SERVICE BULLETIN

Classification:	EM94-002	Section:	Engine Mechanical	Models:	See Below
Reference:	TECHNICAL BULLETIN NTB94-041			Date:	April 14, 1994

BROKEN EXHAUST MANIFOLD STUD

APPLIED MODELS: Only Those Equipped w/VG30E Engine

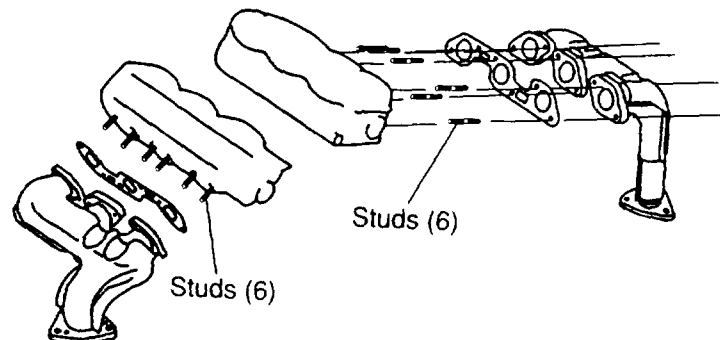
The exhaust manifold stud has been changed for improved durability. Use the following procedure to repair vehicles which exhibit excessive exhaust noise due to exhaust manifold stud breakage.

1. Remove the exhaust manifold on the side of the engine with broken stud(s). (Figure 1) For additional information, refer to the **EM** Section of the appropriate Service Manual.

2. Replace the broken stud(s) and the front and rear studs **only** using the **improved part, P/N 14065-V5003**.
3. Replace the exhaust manifold gasket and the exhaust manifold with new parts. Refer to the EM Section of the appropriate Service Manual for proper torque values for the fasteners. Refer to the Parts Catalog/Microfiche for applicable P/N's.
